Installation Update

This bulletin clarifies the installation protocol recommended by DiversiTech for condensate switch products CS-1, CS-2 and CS1200.

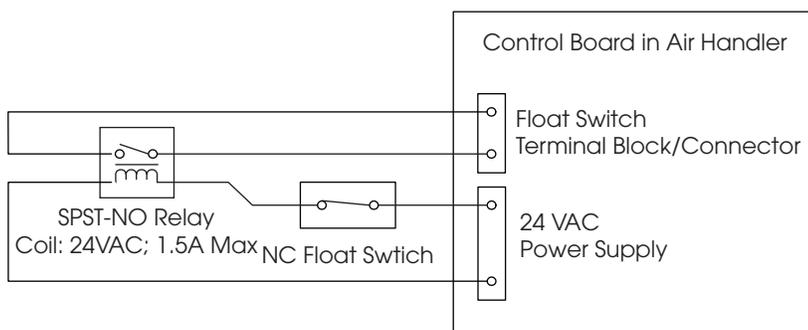
Description: Some **Communicating HVAC Systems** using a dedicated condensate overflow safety switch shutdown input will require the use of an additional (optional) relay. The additional relay is only required if, after the installation of the above products, the HVAC system does not properly shutdown during verification testing.

And finally, check that the system shuts down as expected. If the unit does not shutdown, your unit is more sensitive to switch characteristics than traditional systems and, therefore, requires a relay. Please proceed to implement the relay solution outlined below.

Action: Use a normally open SPST relay with a 24VAC coil (DiversiTech part # D90-290Q or equivalent) to break the condensate overflow safety shutdown input circuit. DiversiTech condensate switch CS-1, CS-2, or CS1200 should be used to make or break control power to the relay coil.
